## 3d Community Church

**659 Graham Rd Sanford, NC**

**9/29/25**

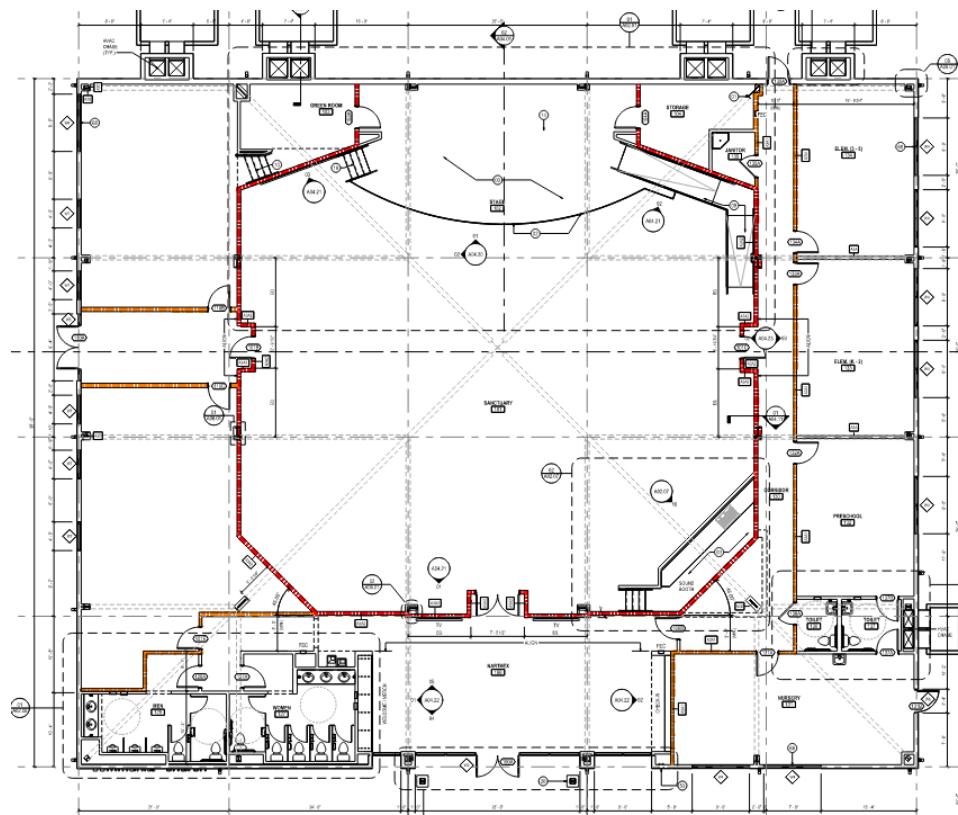
General contractor shall extend the one and two-hour fire rated wall framing and sheetrock tight to the roof insulation/tarp system. Apply fire caulk at the top of sheetrock. Allow deflection at the roof structure. — Follow UL Designs UL419 and V449.

Provide top of wall condition at rated walls indicated in red and orange below.

Hilti Detail CJ-D-0008 is good for 1, 2 and 3 layers of Sheetrock as well.
